R20TS0881EJ0100

Integrated Development Environment for Capacitive Touch

Workbench6

Notes on R_Set_Cap_Touch_Initial_Tuning

After modification: "initial_offset_tuning" of "r_ctsu.c". Add the processing shown in red.

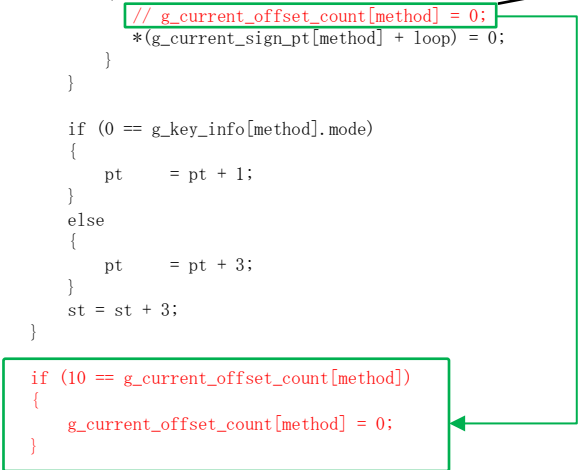
End condition that might cause a problem Because the continuation determination counter and integration of increased/decreased amount of CTSUSO0.CTSUSO bit are not cleared, the counter and integrated value might overflow.

The CTSUSO bit is updated. Adjustment is determined to be completed while the measurement value is unchecked.

During the loops (the number of valid channels), the continuation determination counter is cleared by the result of the channel being determined. As a result, determination of the next channel is suspended for the next 10 calls, thus extending the time for initialization.

if (10 == g_current_offset_count[method])
    {
        if ((OFFSET_CNT_PLUS >= *(g_current_sign_pt[method] + loop)) && (OFFSET_CNT_MINUS <=
        *(g_current_sign_pt[method] + loop)))
        {
            *(g_touch_tuning_info[method].result + loop) = 1;
            *(g_dtc_write_data[method] + st) = (*(g_dtc_write_data[method] + st) & 0xFC00) +
            *(g_touch_tuning_info[method].ctsuso + loop);
        }
        else
        {
            // g_current_offset_count[method] = 0;
            *(g_current_sign_pt[method] + loop) = 0;
        }
    }

if (10 == g_current_offset_count[method])
{
    g_current_offset_count[method] = 0;
}

Delete this
